Access Compliance Report

Public Rights-of-Way

Intersection ID: 28975	Main Street: BANNINGTON_RD	Cross Street: NORTHBURY_LN	Location: NW
ADA ID: C1A661BECEE6	Ramp Type: PerpDiag	Initial Pass/Fail: Fail	Overall Compliance: No
		Severity Score: 60

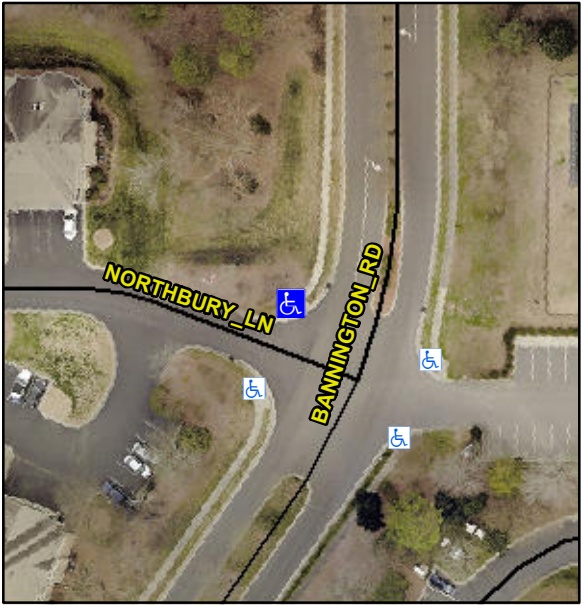
Codes/Mitigation Info/Possible Solution			Field Measurements/Component Compliance		
 <p>Street 1 Name NORTHBURY LN</p> <p>Stop Condition-Street 2 StopSign</p> <p>Street 2 Name BANNINGTON RD</p> <p>Stop Condition-Street 1 None</p>	Possible Solutions:		Compliance	Description	Data
	Remove & Replace Curb Ramp With Two New Directional Ramps or Equivalent.		Yes	Ramp Slope (%)	6.0
			No	Ramp XSlope (%)	7.1
			N/A	Flare Type LT	N/A
			N/A	Flare Slope LT (%)	N/A
			N/A	Flare Traversable LT?	N/A
			N/A	Flare Traversable RT?	N/A
			N/A	DWS Provided?	N/A
			N/A	DWS Contrast?	N/A
			N/A	DWS Length (in)	N/A
			N/A	DWS Full Width?	N/A
			N/A	DWS Offset (in)	N/A
			N/A	Gutter Slope (%)	N/A
			N/A	Gutter X Slope (%)	N/A
			No	Painted X Walk2?	No
			To S	X Walk 2 Direction	To E
			N/A	X Walk 2 Width (in)	N/A

6.1	X Walk 2 Slope (%)	1.8
			2.0	X Walk 2 X Slope (%)	6.3
			N/A	Ramp inside XWalk2?	N/A
<p>Surveyor Notes:</p> <p>N/A</p> <p>PROW/ADA:</p> <p>Not Found, R304.5.1, R304.5.3</p> <p>Total Cost: \$ 3200.00</p>			N/A	Clear Space?	N/A
